Mehlville R-IX School District
2900 Lemay Ferry Road
St. Louis, Missouri 63125

SUBJECT: Addendum No. 3 to the Bidding Documents for:

Mehlville School District – Bus Transportation Facility Project

Date	#	Description
9/23/2026	ADD-3	ADDENDUM 003
ADDENDUM 003 9/23/2026		
ISSUED FOR BID 09/1/2026		
Team Drawn By: RDF Checked By: JRB		
Sheet Title FOUNDATION DETAILS		
Sheet No. S104

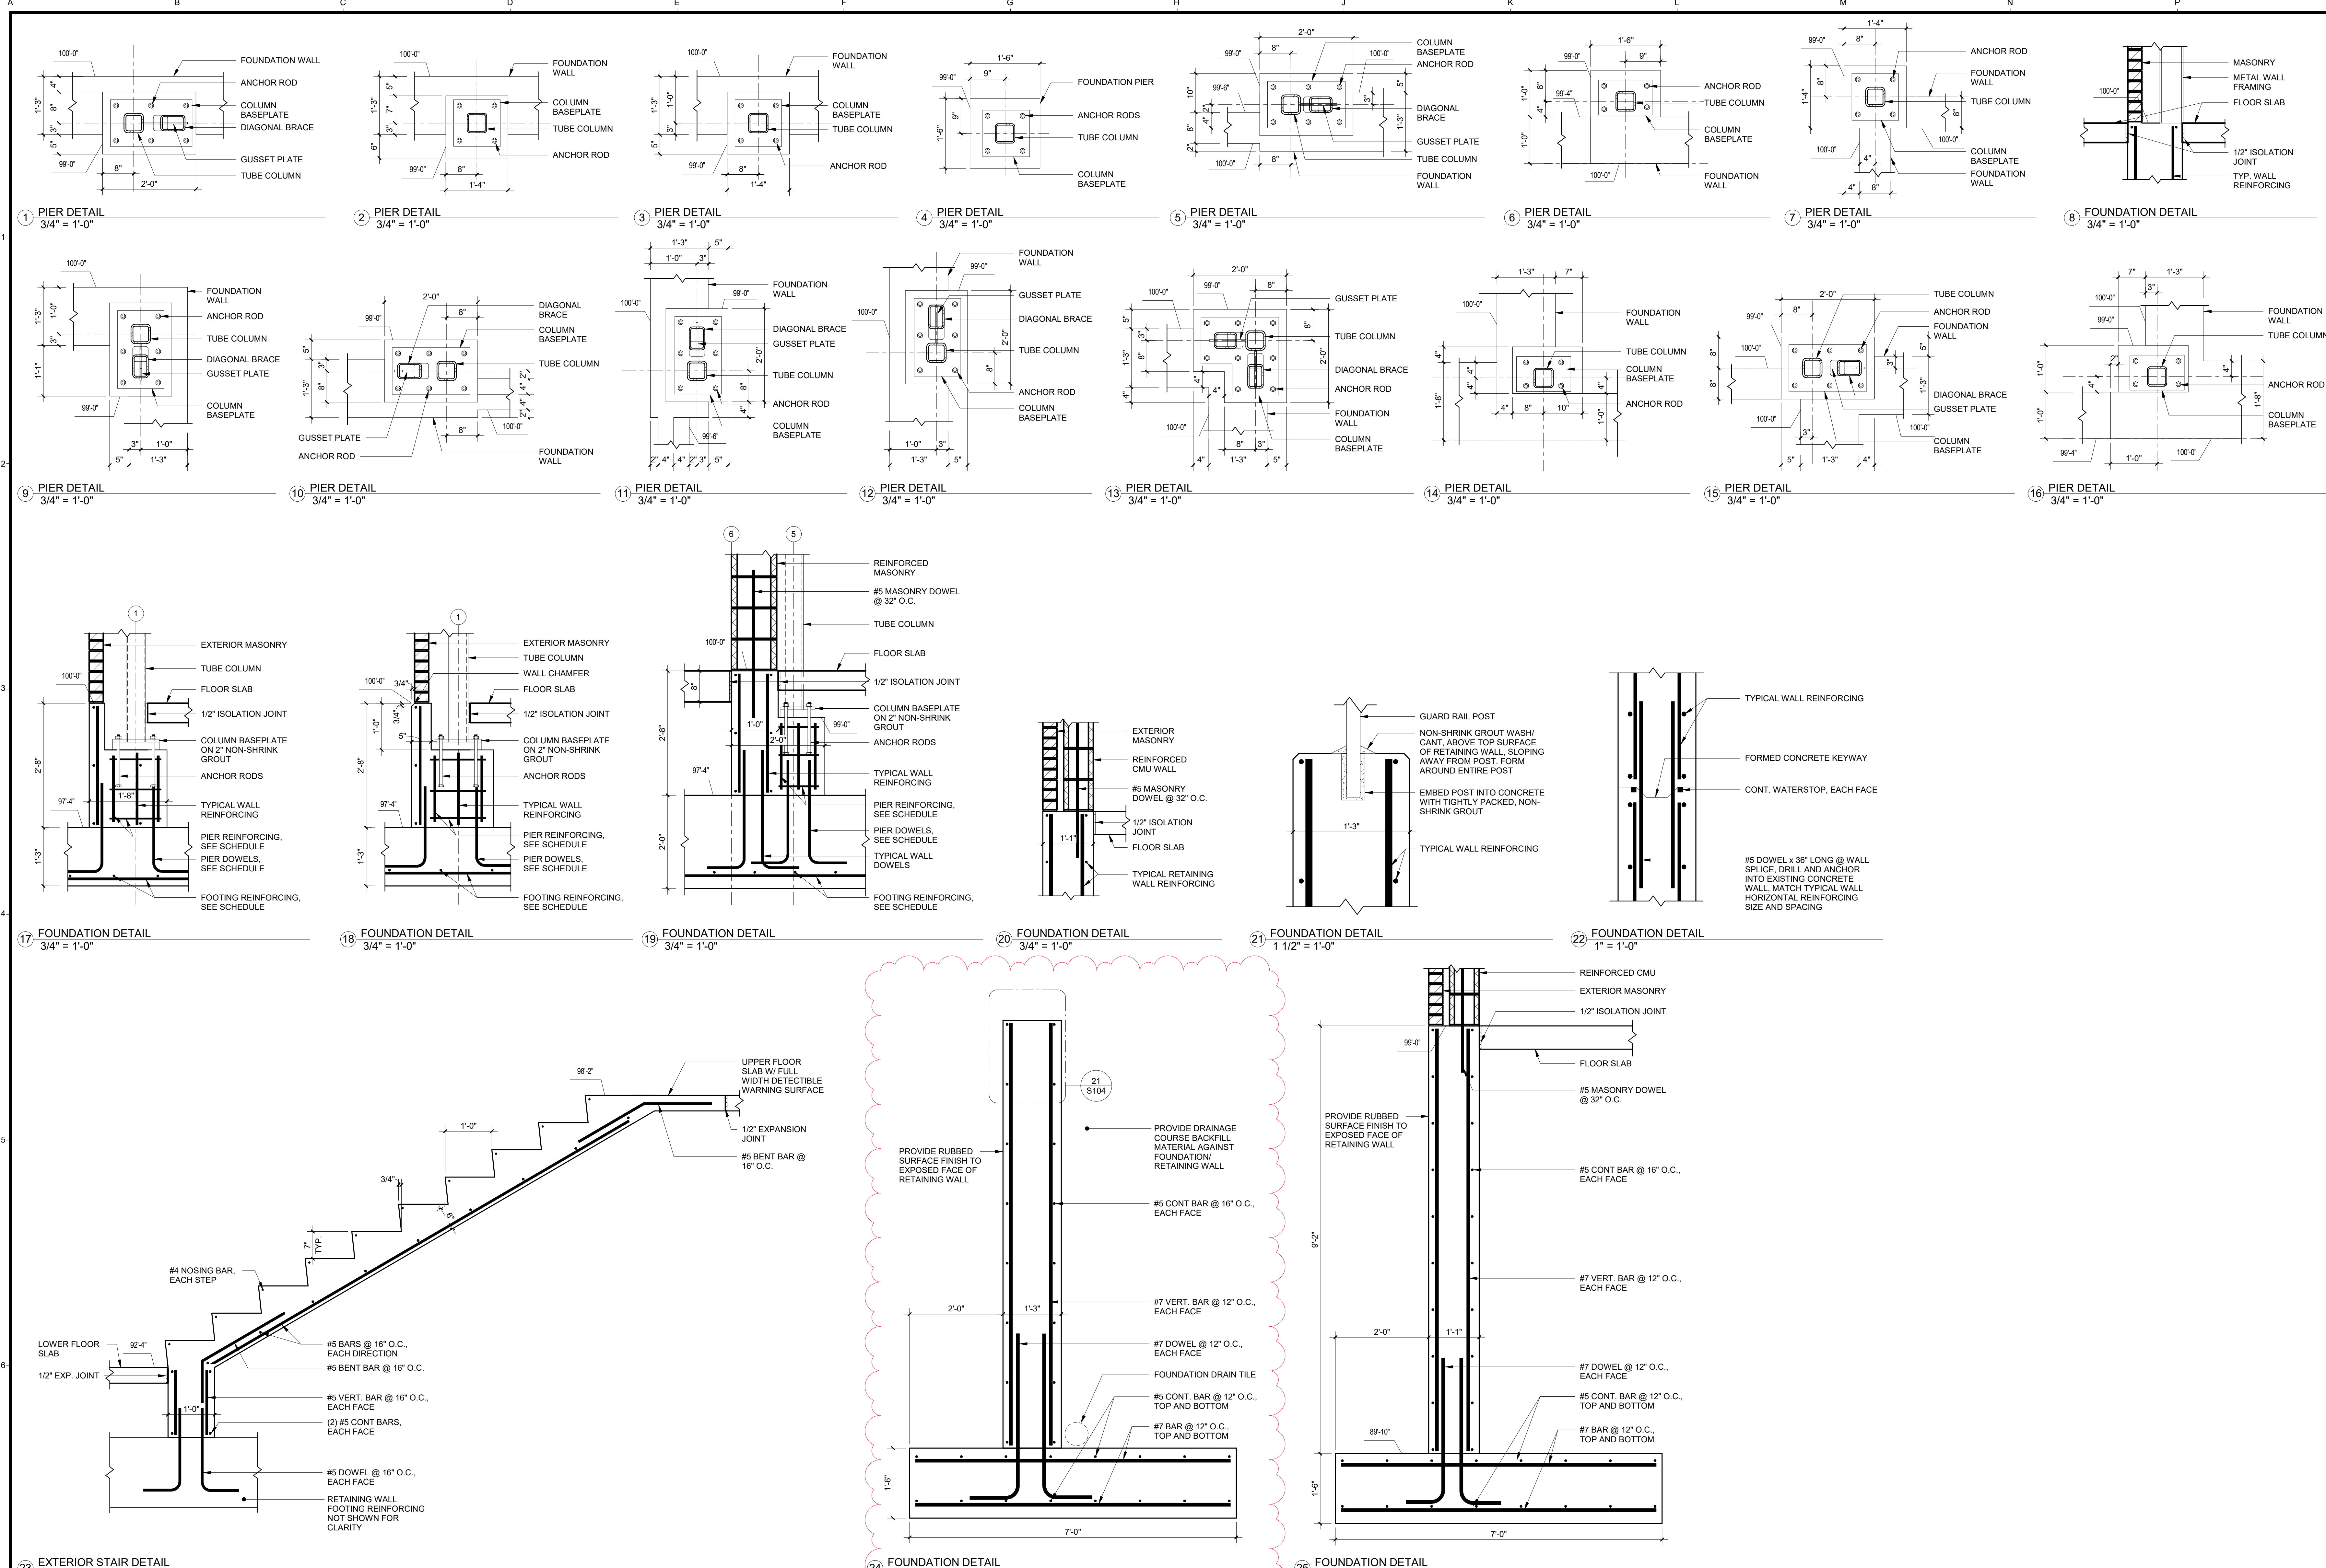
- 10. Sheet S101 - FOUNDATION PLAN
 - a. **ADD** foundation plan general note #13
- 11. Sheet S104 - FOUNDATION DETAILS
 - a. **REVISE** detail 24 as noted
